**Change Nr, Title** 20007911, Add UKCA marking  
**Date of issue** 28.06.2021

UKCA marking introduced on affected products.

Figure 1: UKCA marking

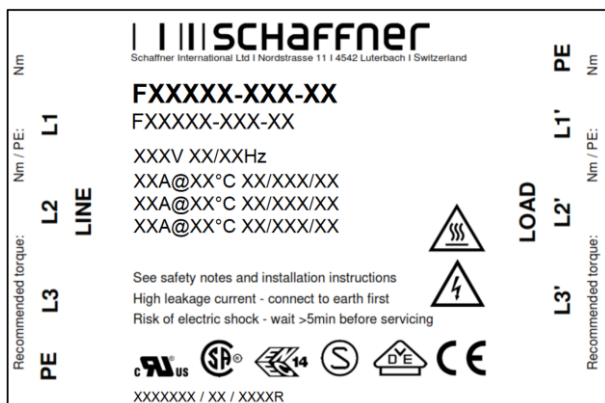
UKCA marking is visible on product label, product box label and data sheet where applicable.
